URBAN DESIGN COMMISSION APPLICATION

Title: Vive

- Please specify
Alteration to Landscape Plan

RE: 4205 Portage Road – Landscaping Mulch

L1
 OVERALL LANDSCAPE

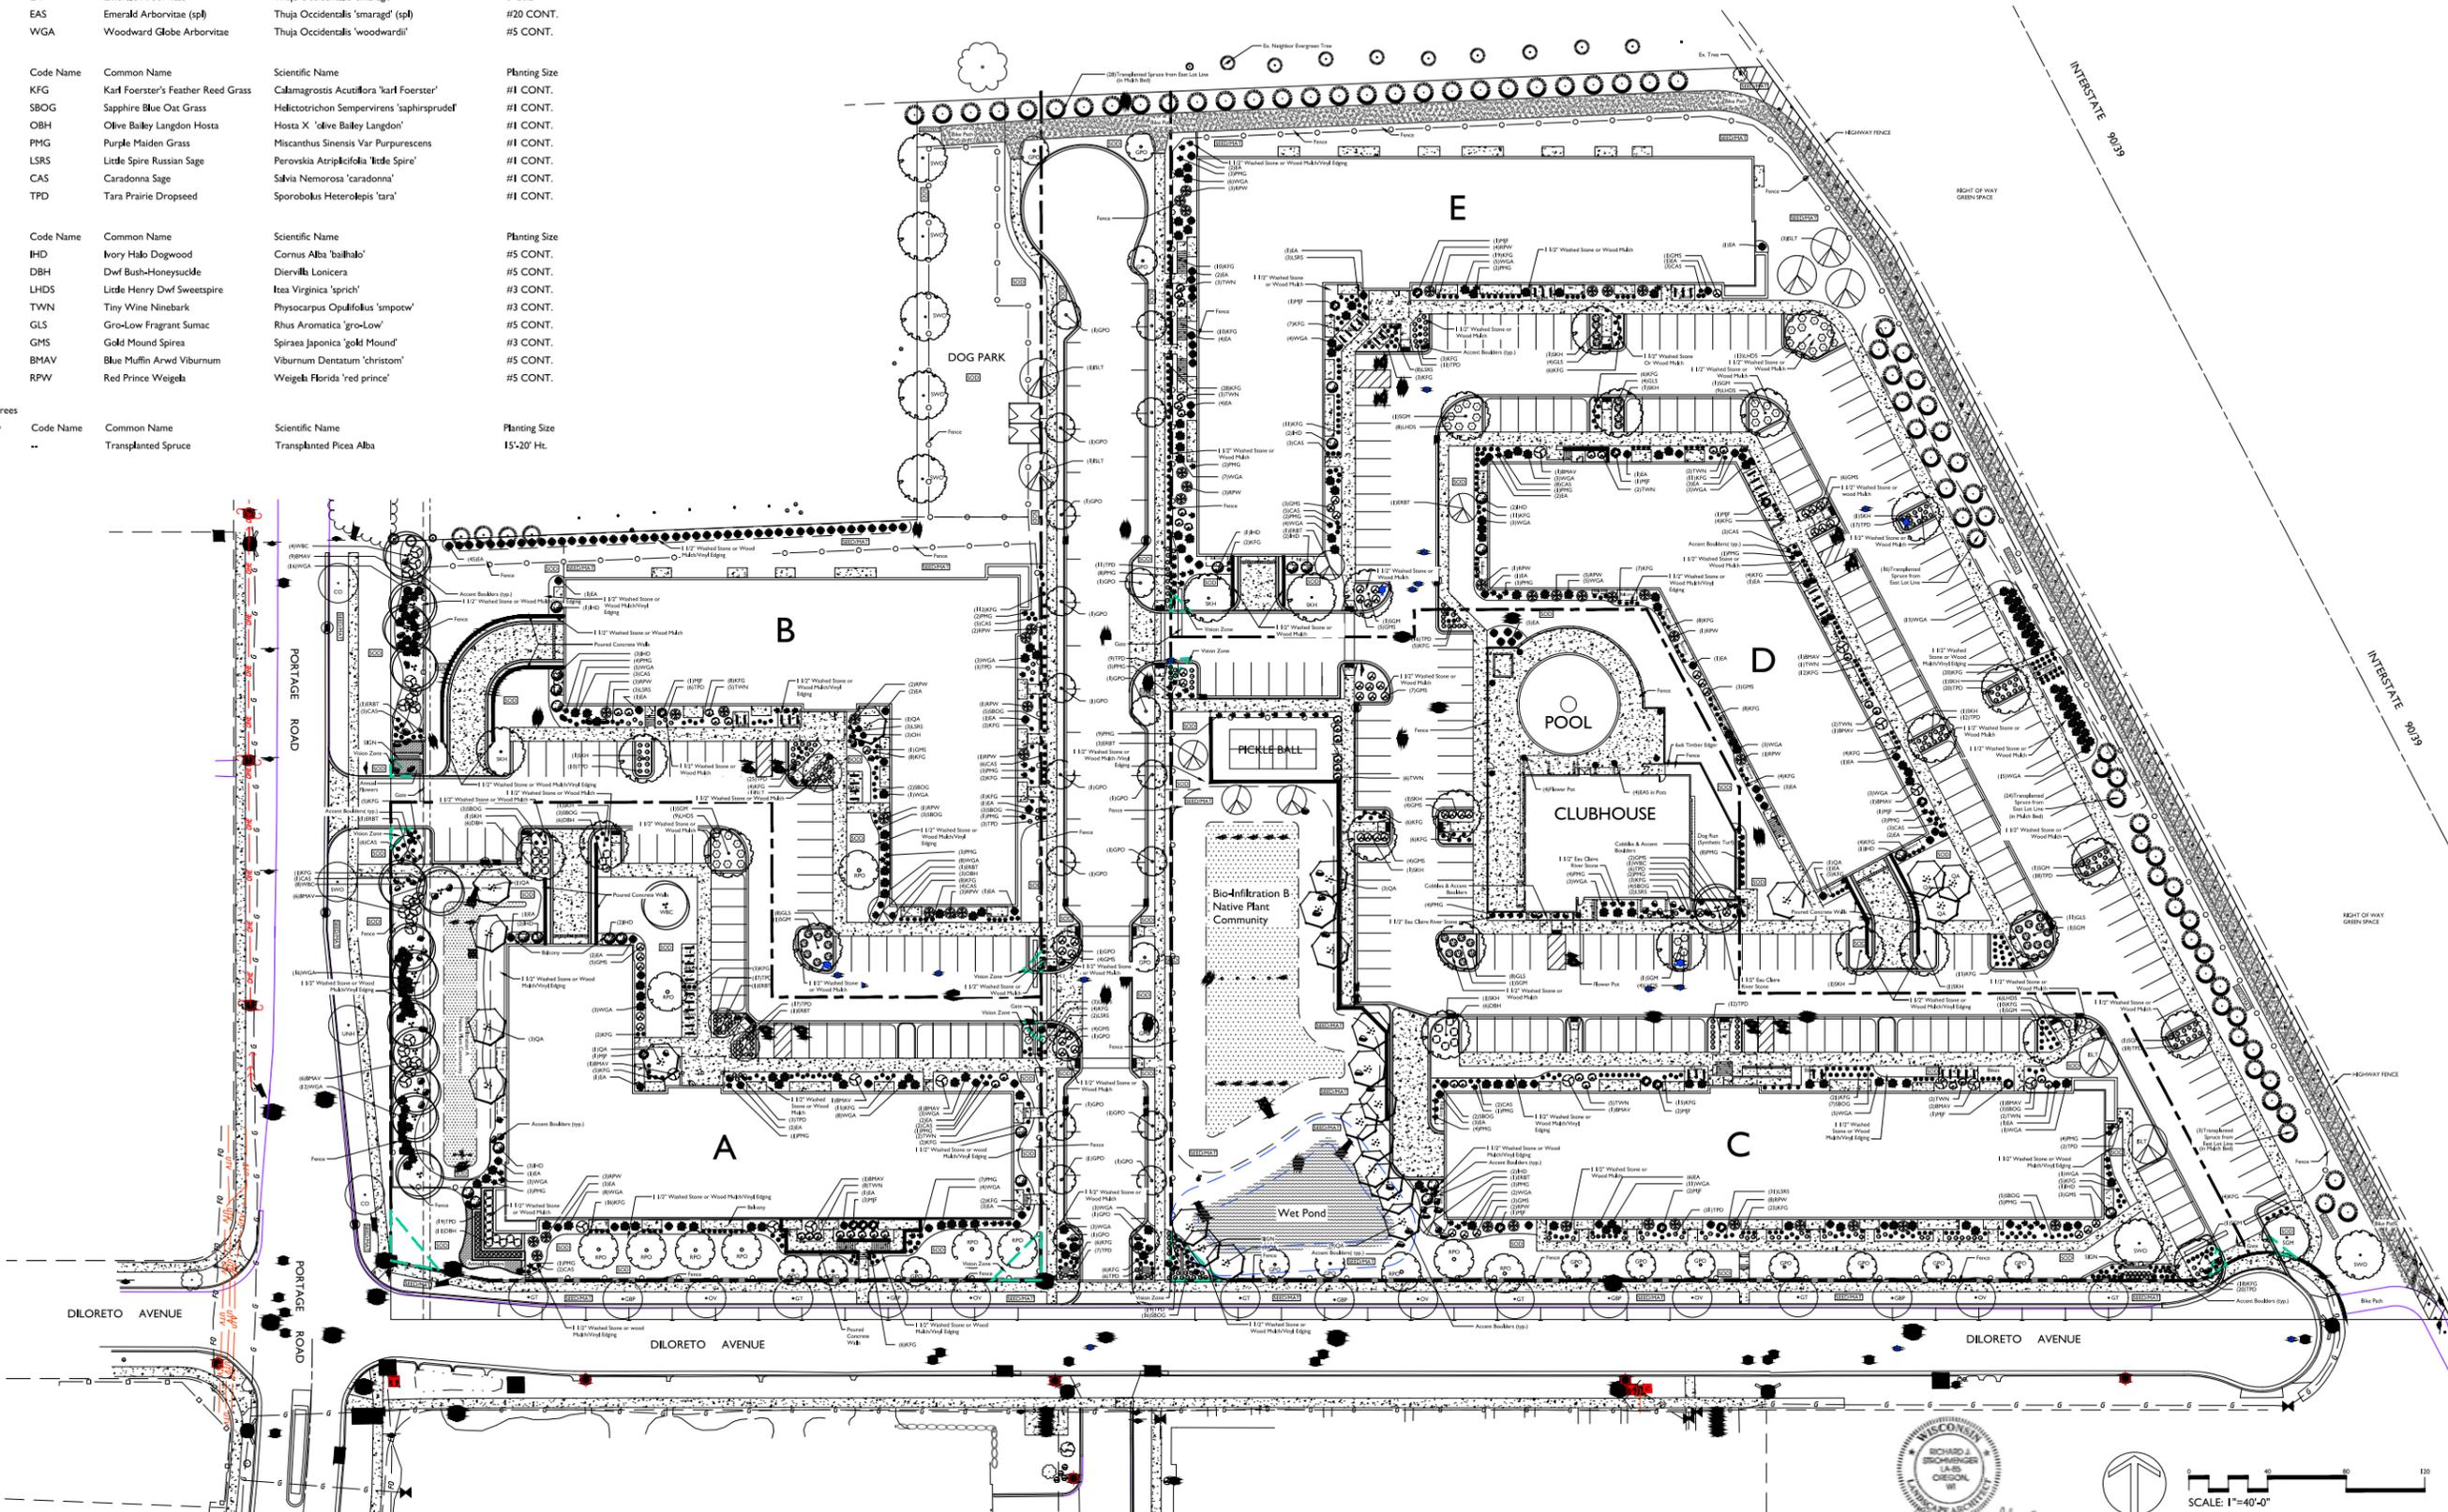
I am writing to request an alteration to the landscaping plan for property located at 4205 Portage Road. The approved plan suggested the use of wood mulch for the landscaping beds; however, we would like to install stone landscaping mulch as allowed by Madison General Ordinances Section 28.142(3)(c).

H) Plant beds adjacent to building foundation and parking islands to be mulched with 1-1/2" diameter washed stone mulch spread to a 3" depth over fabric weed barrier OR Processed wood mulch spread to 3" depth with pre-emergent herbicide granules.
